REVISION	DATE	DESCRIPTION	BY
3	Jul 90	As built - No change	D.S.
4	13 May 88	Added Interceptor Ditch No. 1	T.D.
DEPARTMENT OF THE ARMY NEW YORK DISTRICT, CORPS OF ENGINEERS NEW YORK, NEW YORK			
DRAWN BY: <i>EJM</i>		SAW MILL RIVER, NEW YORK	
CHECKED BY: <i>D.S.</i>		ARDSLEY FLOOD CONTROL PROJECT	
DESIGNED BY: <i>Thomas J. ...</i>		MAIN CHANNEL PROFILE	
REVIEWED BY: <i>James ...</i>		ARDSLEY	
SUBMITTED: <i>C. ...</i>		RECOMMENDED: <i>Stanley ...</i>	
APPROVED: <i>W. ...</i>		SCALE AS SHOWN	
DATE: 20 JULY 1987		DRAWING NUMBER: CC-ARD-411	
		SHEET 11 OF 48

Designed by: 	SAW MILL RIVER, NEW YORK
Drawn by: EJM	ARDSLEY FLOOD CONTROL PROJECT
Checked by: D.S.	PROFILES-INTERCEPTOR
	DITCHES NO. 1 & 2
Reviewed by: 	ARDSLEY CHIEF, ENGINEERING DIVISION
Approved by: 	Sheet reference number: CC-ARD-413
Concurred by: 	Date: 20 JULY 1987
ASST. CHIEF, DESIGN BRANCH	Scale: AS SHOWN
	Sheet 13 of 44

SAW MILL RIVER, NEW YORK
ARDSLEY FLOOD CONTROL PROJECT
CROSS SECTIONS—STA 0+27U TO STA 8+02U

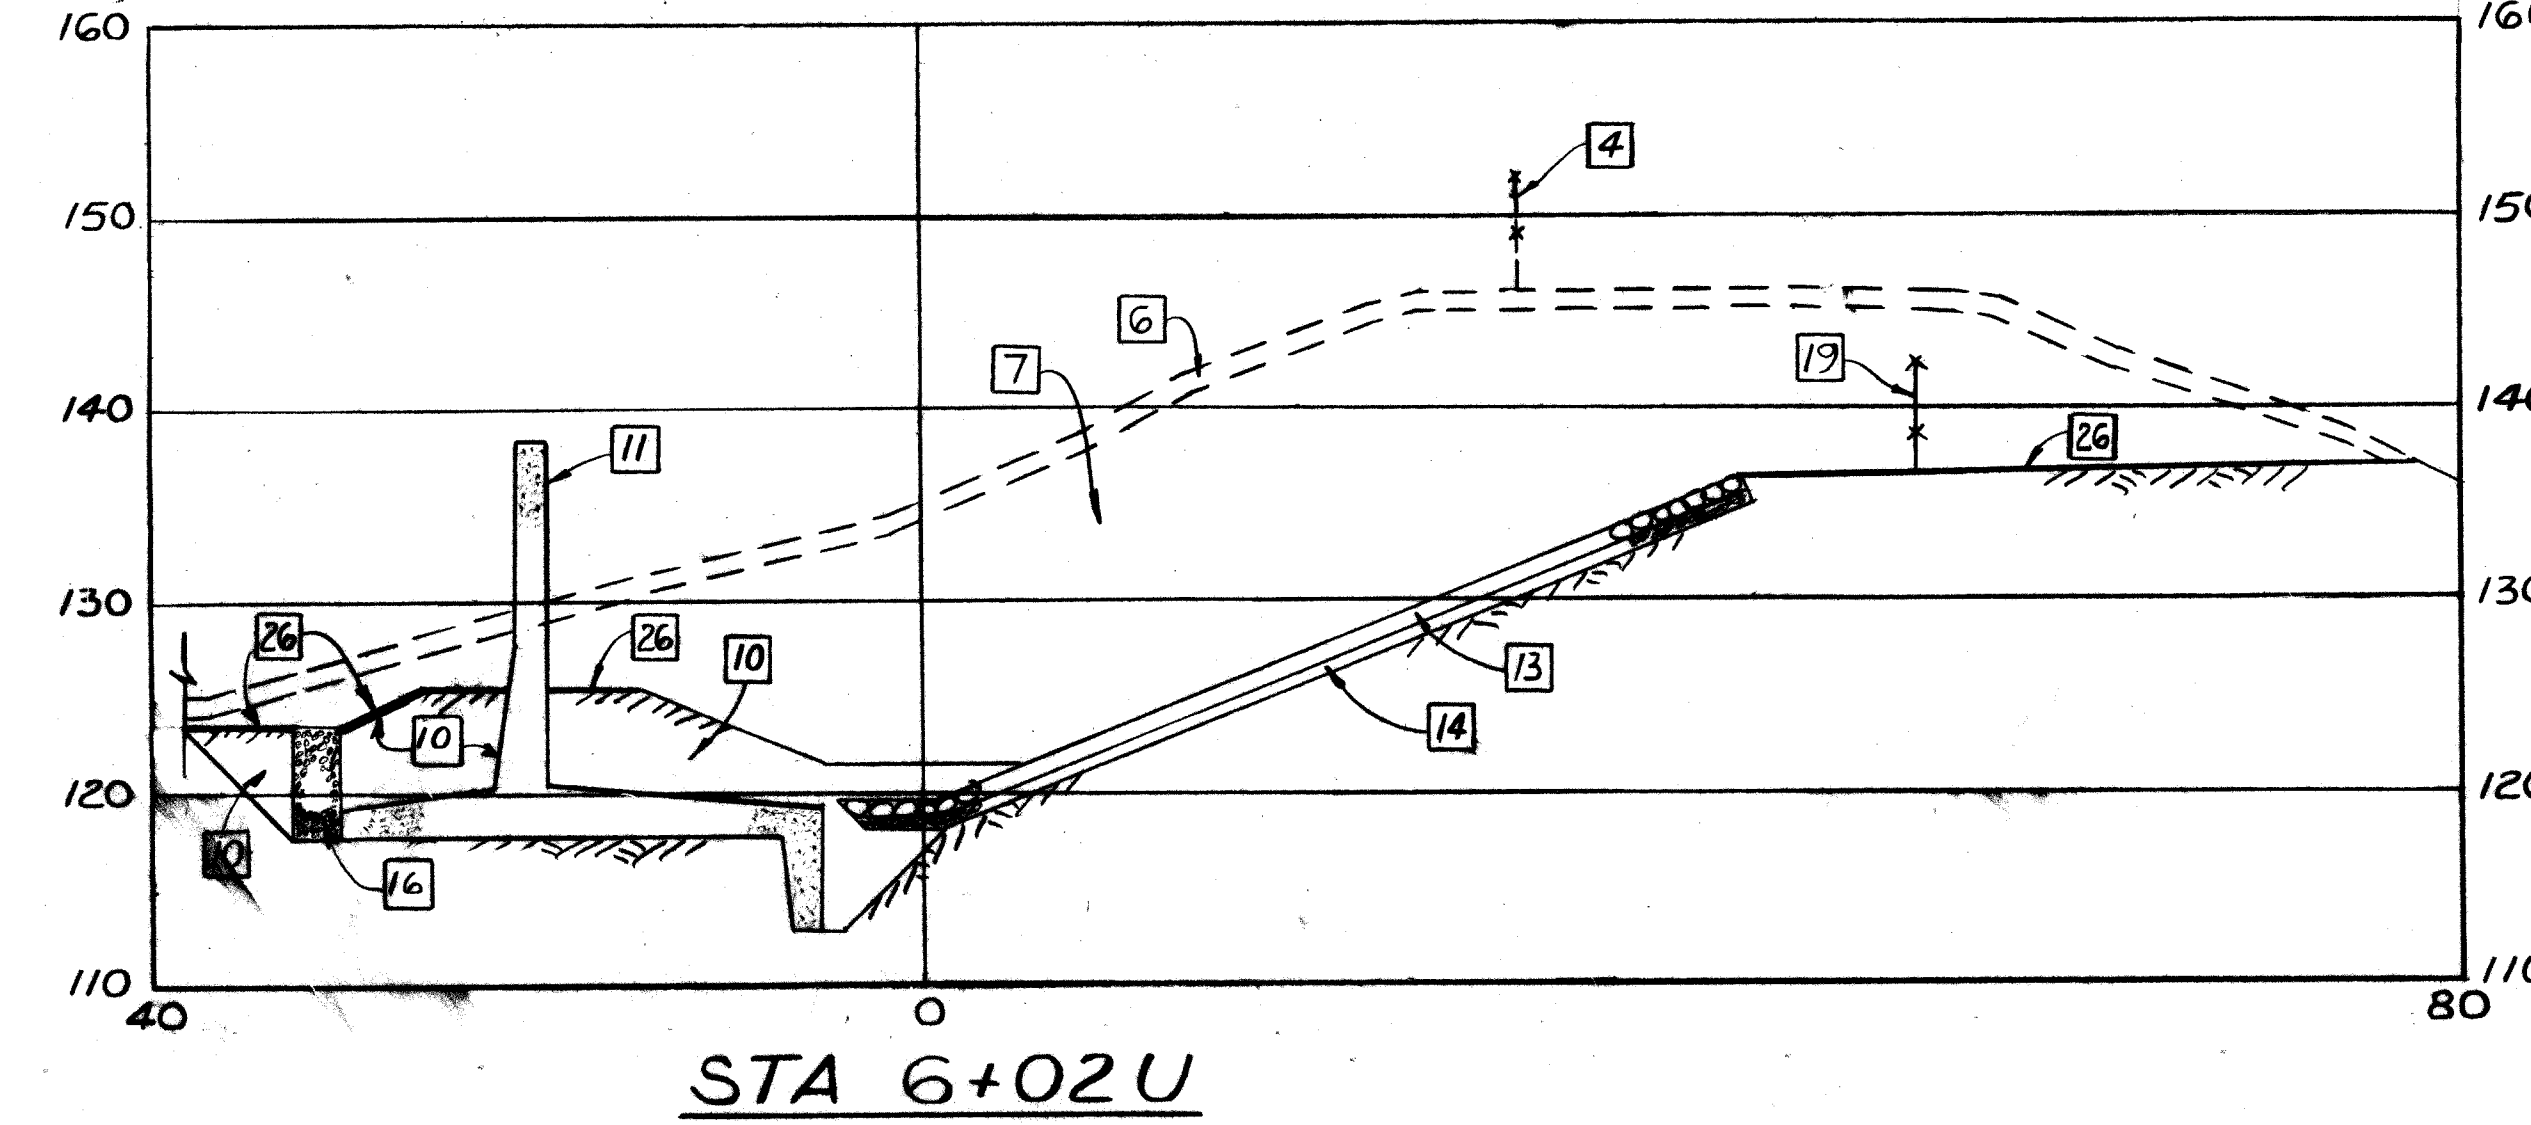
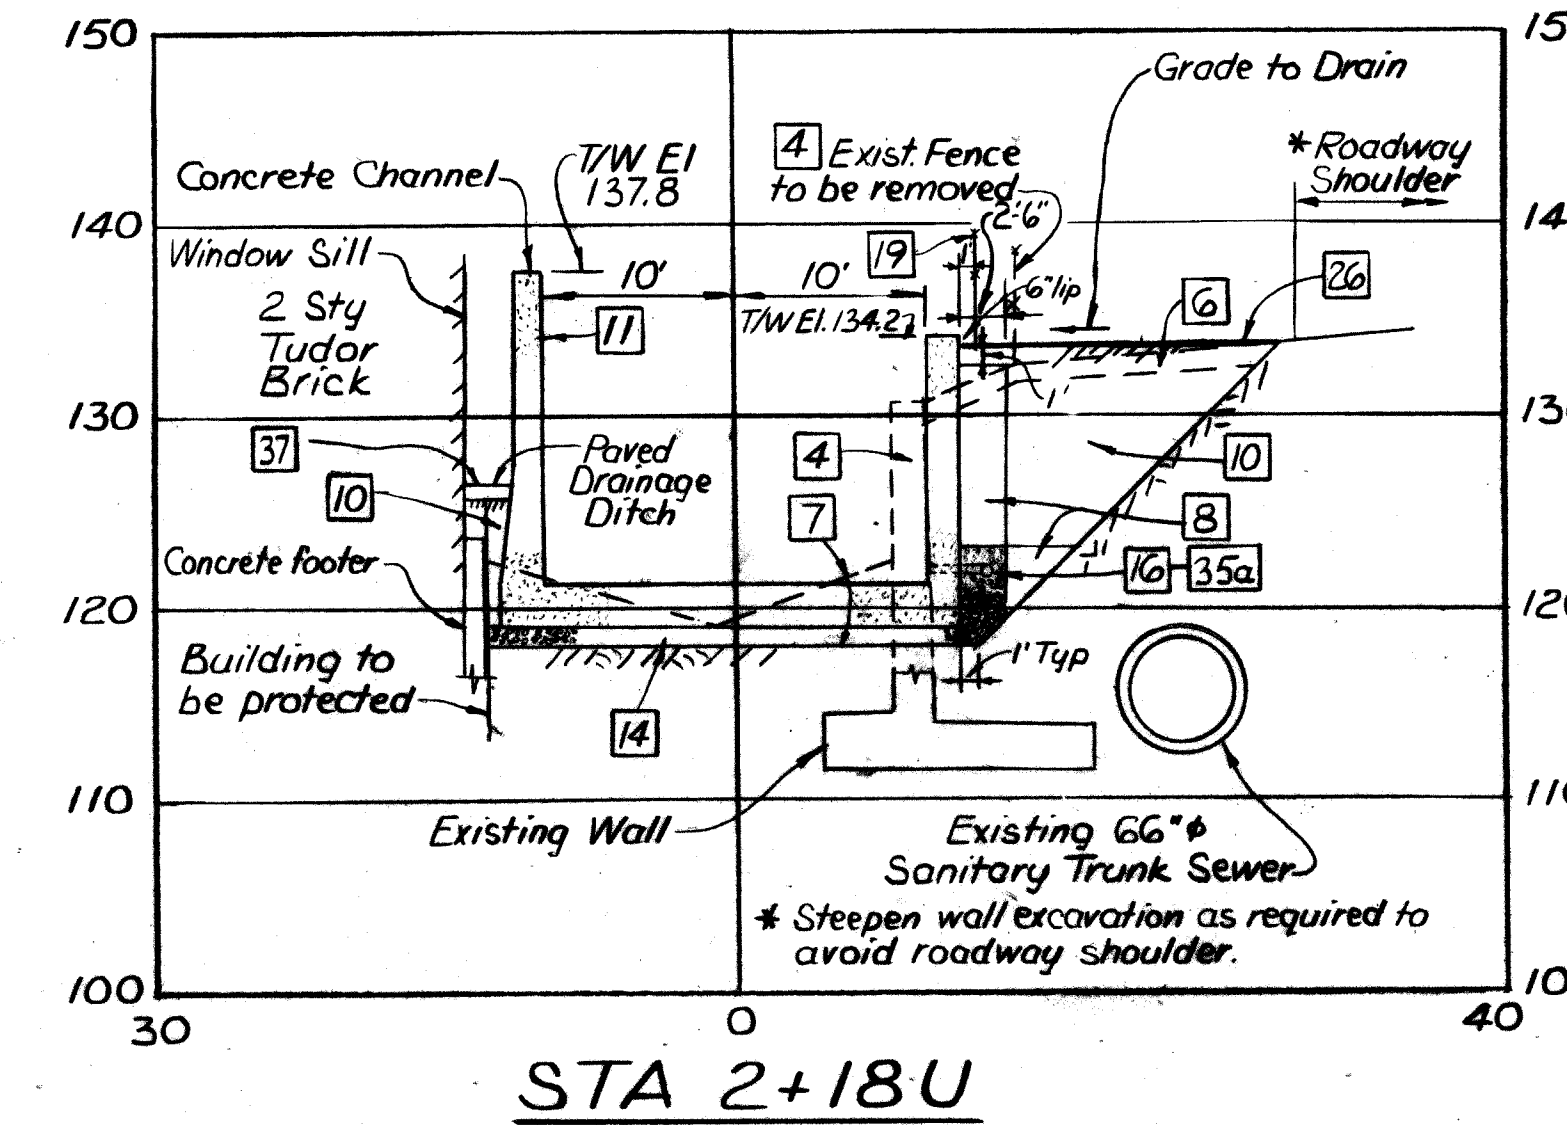
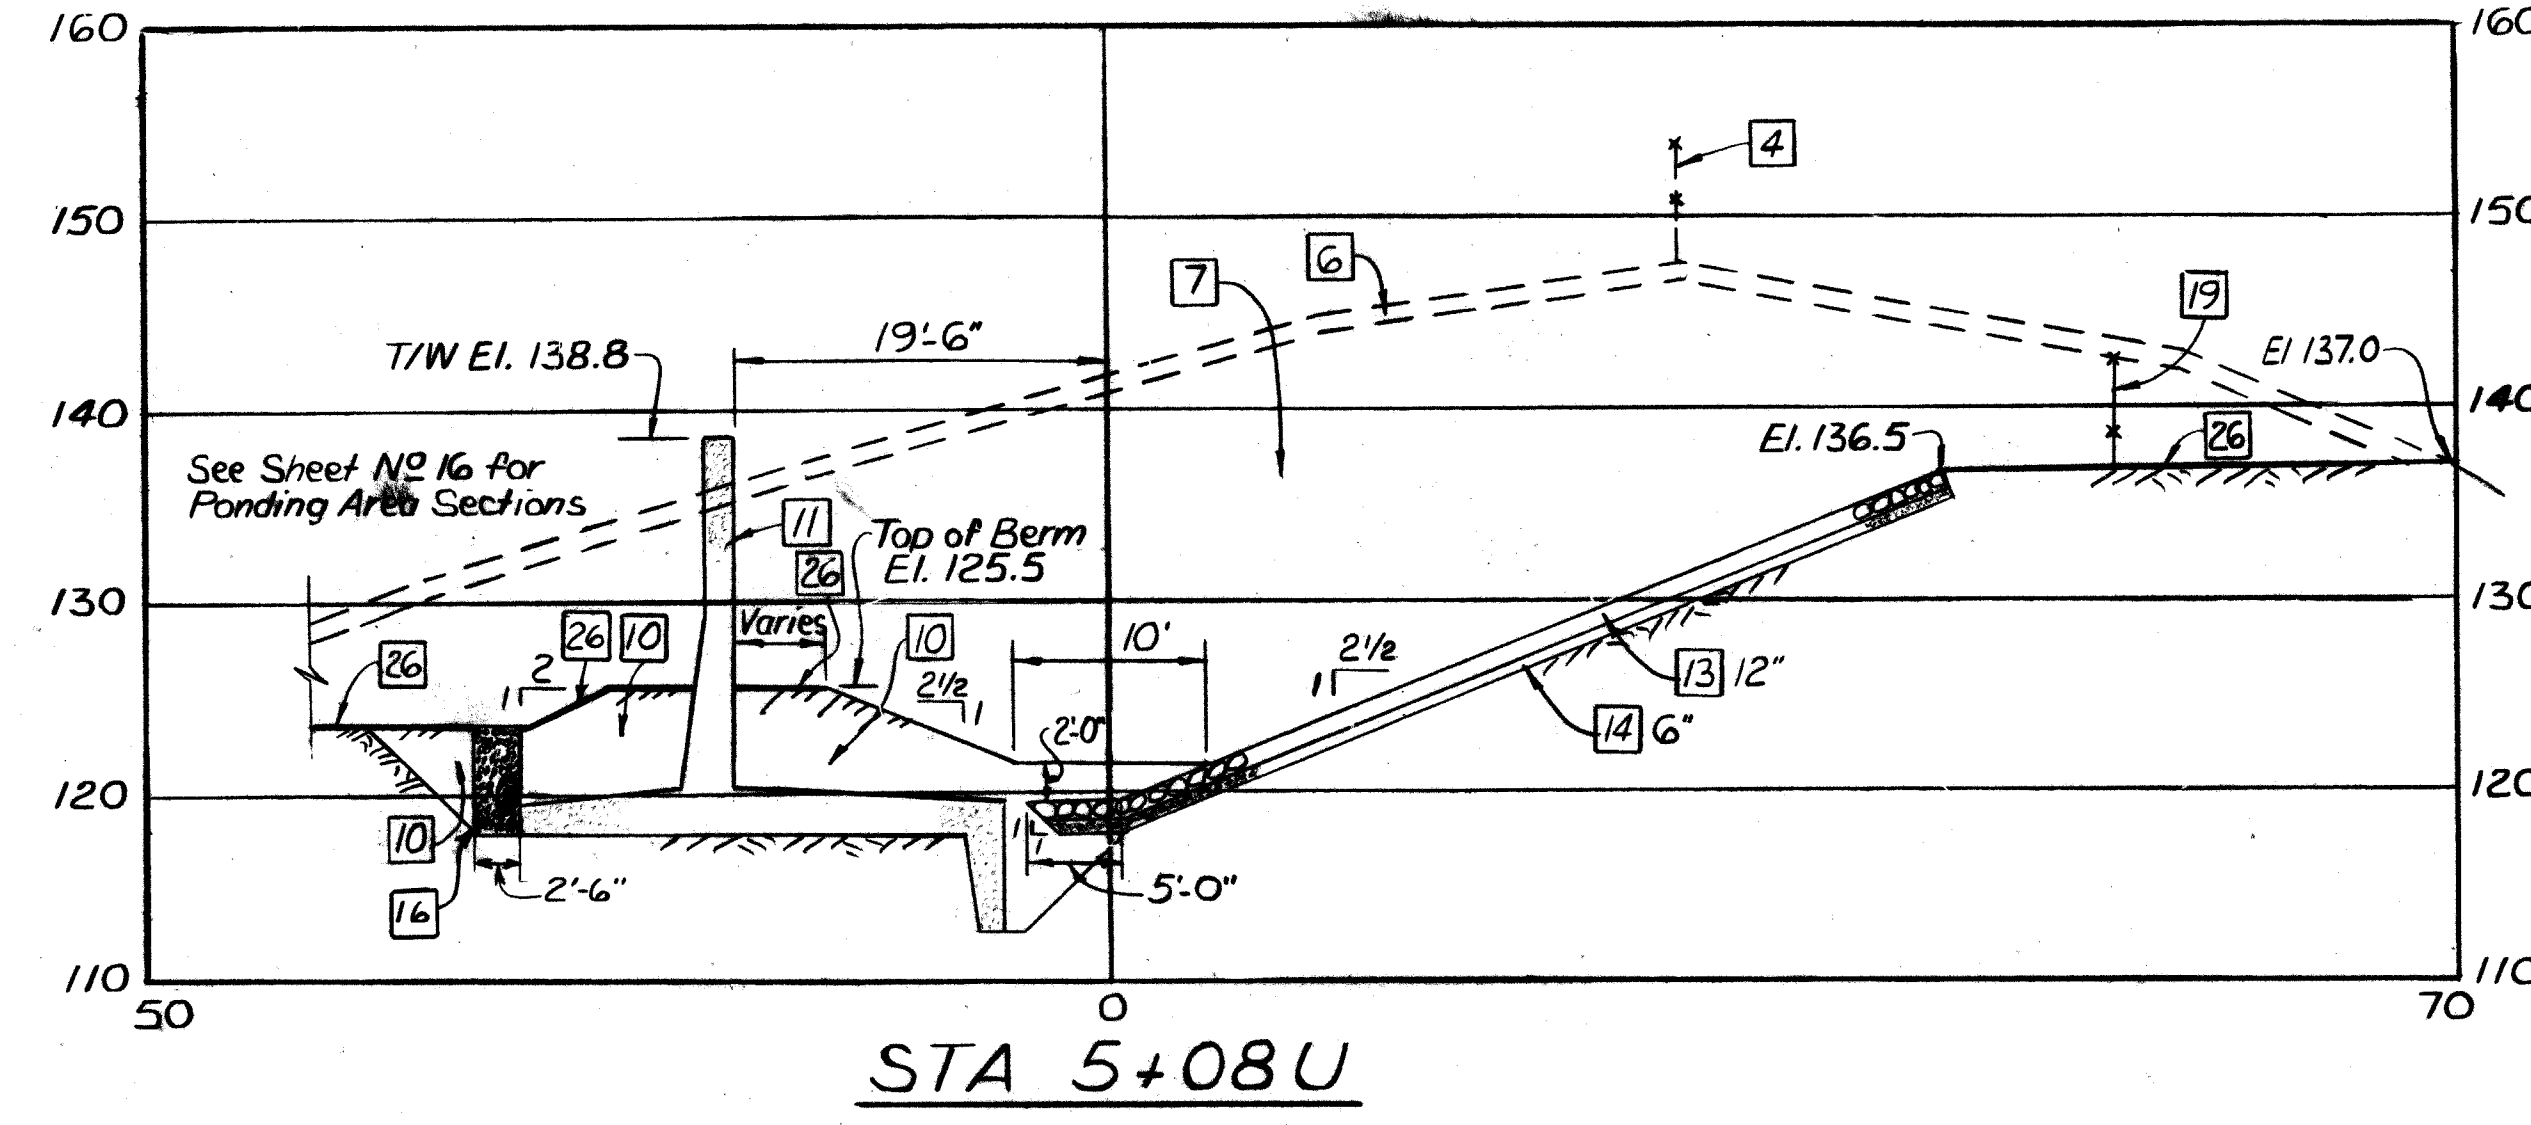
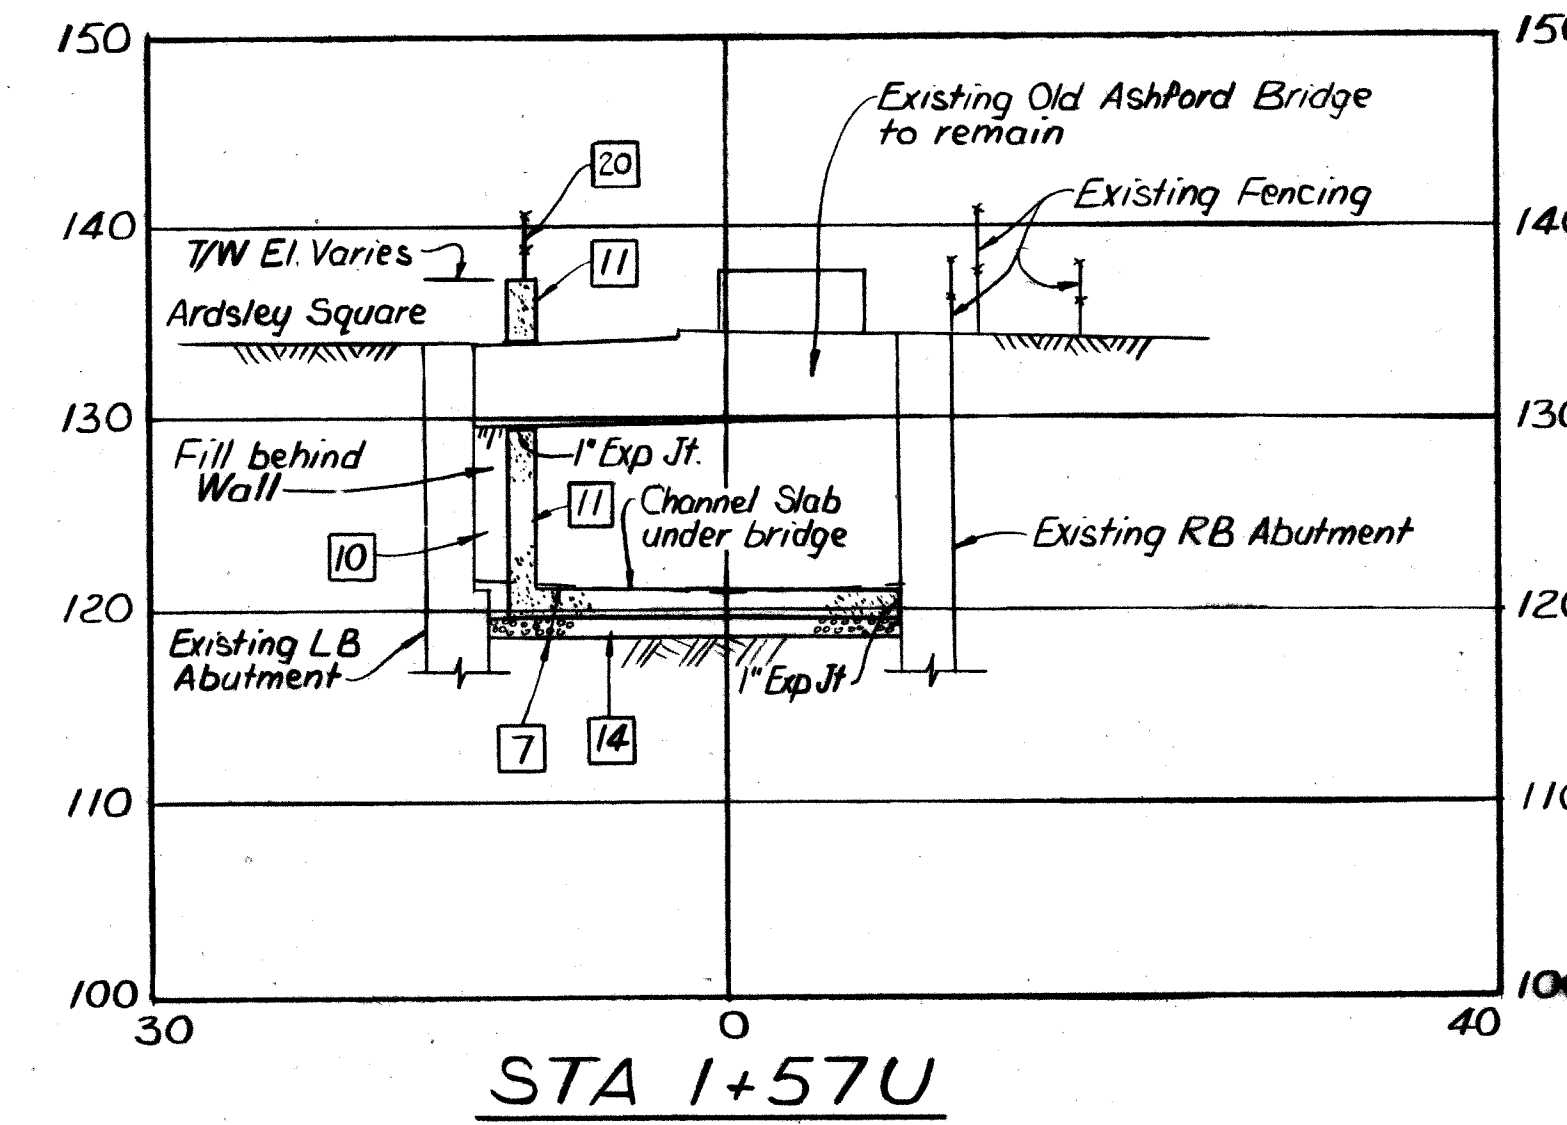
Revision	Description	Date	Approved
1	curtain walls replaced by piles - as built	4/14/90	O.P.
2	Revised Fence Location STA 2+18U, STA 3+17U	13 May 98	T.D.
